AGENDA PORTLAND PLANNING BOARD MEETING

The Portland Planning Board will hold a meeting on Tuesday, September 10, 2019, Council Chambers, 2nd Floor, City Hall, 389 Congress Street. **Public comments will be taken for each item on the agenda during the estimated allotted time and written comments should be submitted to planningboard@portlandmaine.gov.**

Memorandum
Planning and Urban Development Department
Planning Division

To: Sean Dundon, Chair and Members of the Portland Planning Board
From: Christian Roadman, Planner
Date: September 6, 2019
Re: 130 Morning Street Residential Development
Project #: PL-000732-2019 CBL: 014 K007
Meeting: September 10, 2019

SCALE: 1/8" = 1'-0"

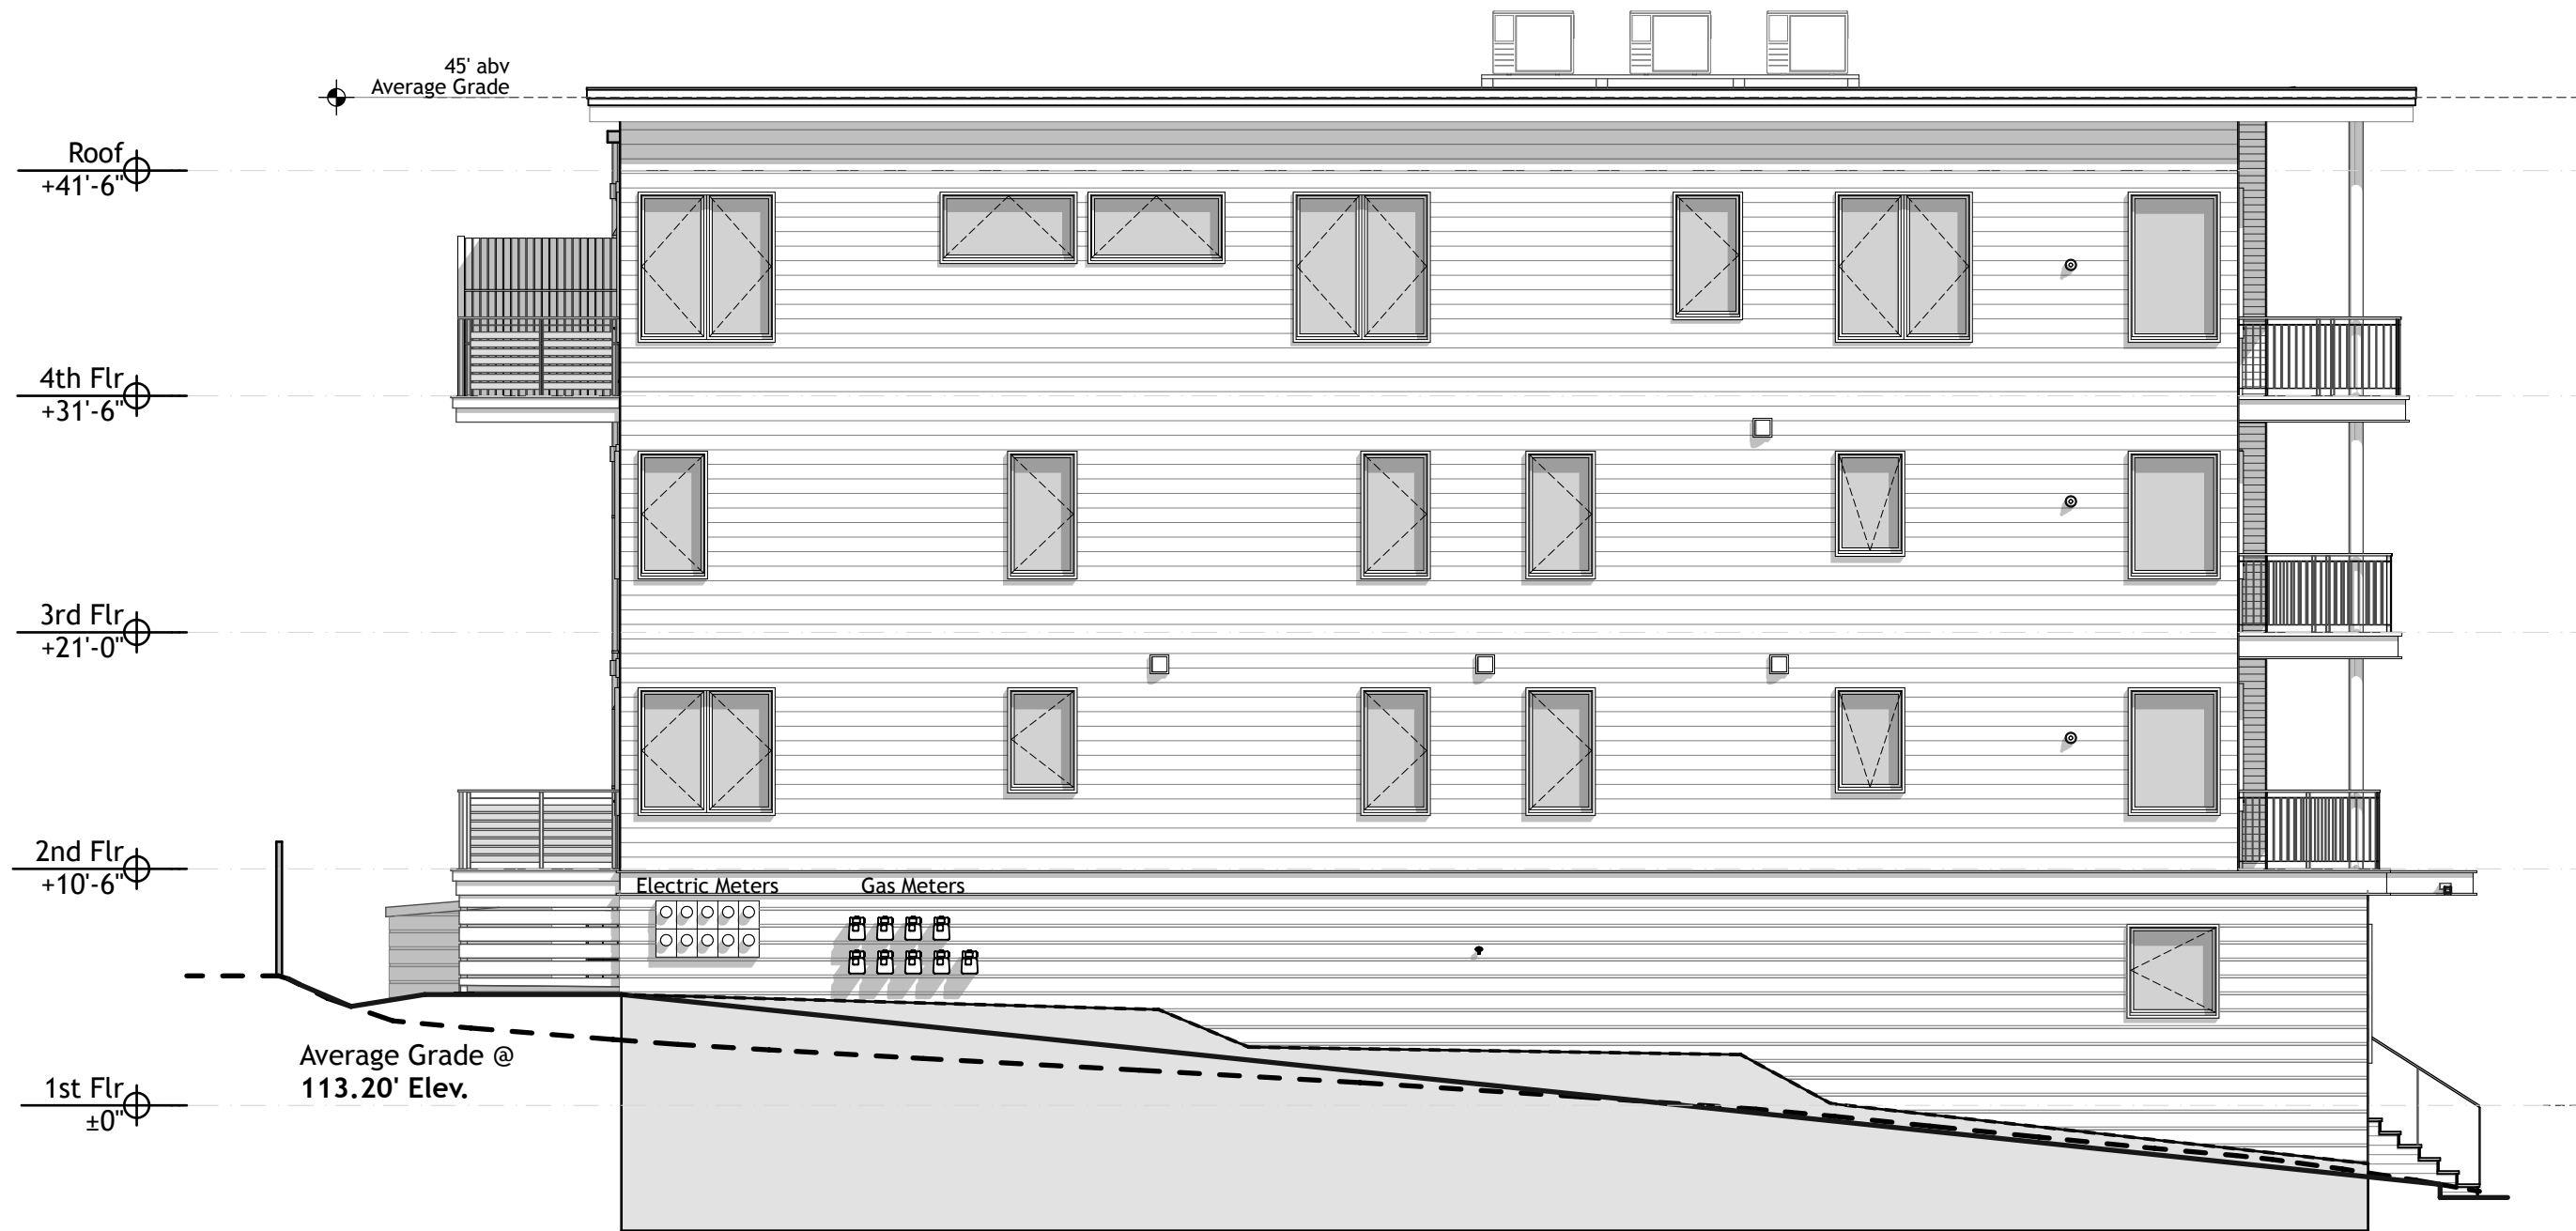
The proposed plan partially conforms to zoning requirements, with some potential required modifications. Rooftop appurtenances, including the parapet, appear to exceed the 45' required maximum height in provided elevations (attachment P15). An updated landscape plan is required and should be used to calculate the landscaped open space requirements. The applicant's current calculation of the open space requirement is unclear given a reference to further calculations on the site plan (attachment P5).

- Roof Form/Appurtenances: The rooftop mechanicals appear to now be positioned taller than the previous version – please explain the revisions to the roofline and these elements.
Suggested Revision: Potentially change the roof line, raise a parapet to create a unified, integrated roof form that also conceals these rooftop appurtenances. Rooftop mechanicals are limited to 5' max above 45' height limit and must be screened per zoning.

Response – Please refer to the revised architectural drawings. The Architect has added a rear parapet to shield the PV panels and condensers on the roof from view from the far side of Emerson street at street level. See sheet R5.

Northeast Morning LLC - Roof Edge cornices were thickened with a Parapet to help hide roof top PV panels and centrally located condenser appurtenances. See sheet R1-R5.
